A Townhouse Development at
Walton Cr Rd/ Village Dr
1805 Walton Creek Road, Steamboat Springs, Colorado 80487

DATE	DESCRIPTION
12/20/21	100% DD
05/20/22	50% CD
06/17/22	100% CD/ PERMIT
09/07/22	PERMIT CORRECTIONS

REVIEWED FOR CODE COMPLIANCE
12/07/2022

A0.00

1 S BLDG- NORTH ELEVATION

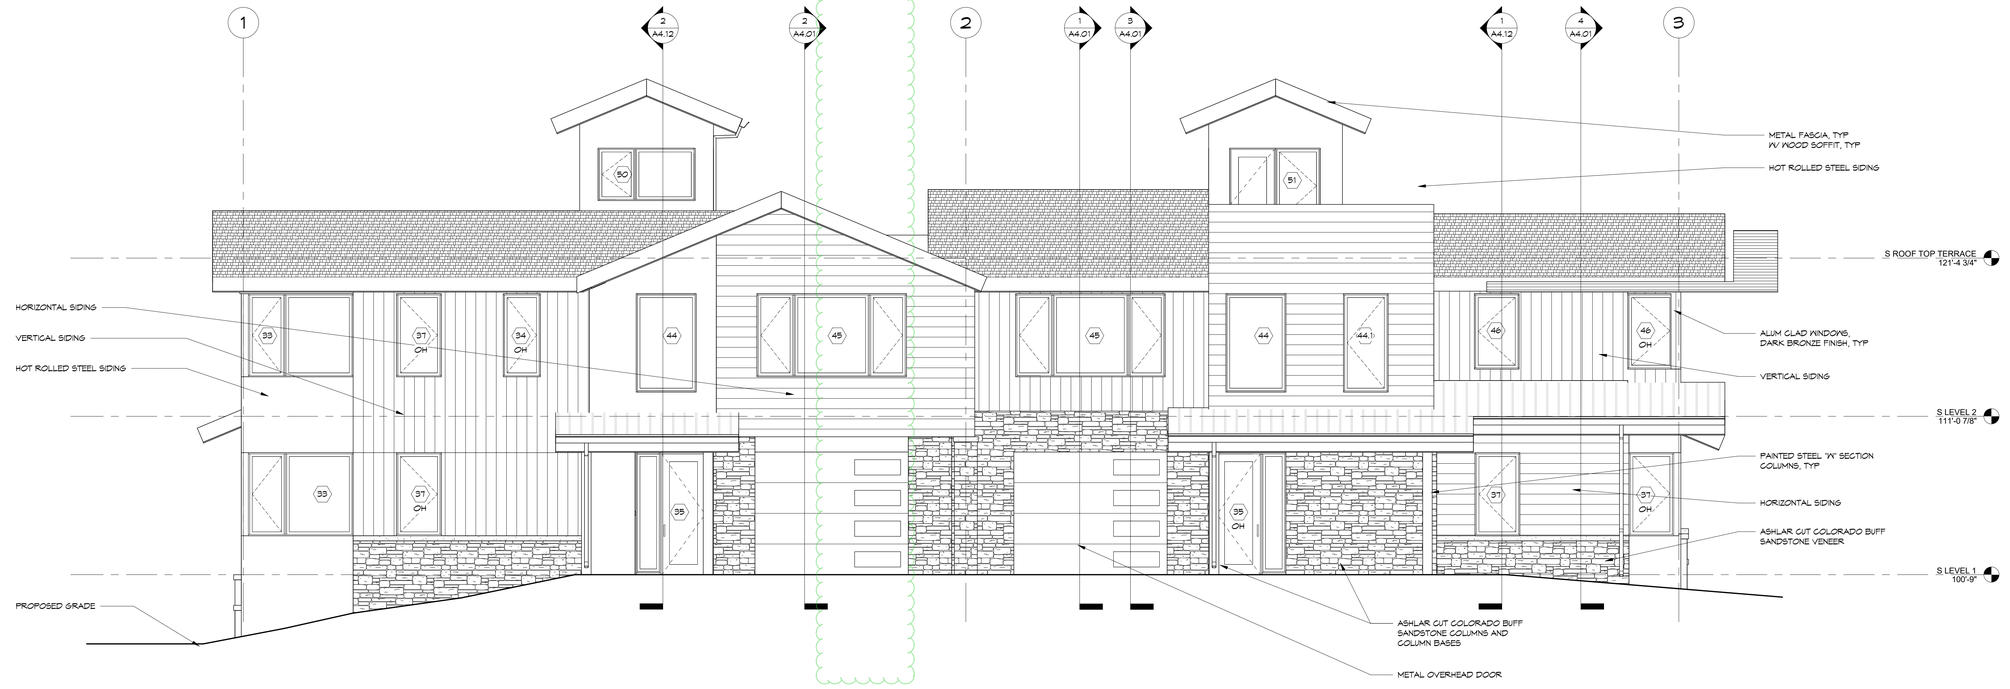
May be helpful to have a cloud on these views showing the 4 feet of FRWT plywood on both sides of the roof, then we can add soffit detail for 1-hour underside protection as well.
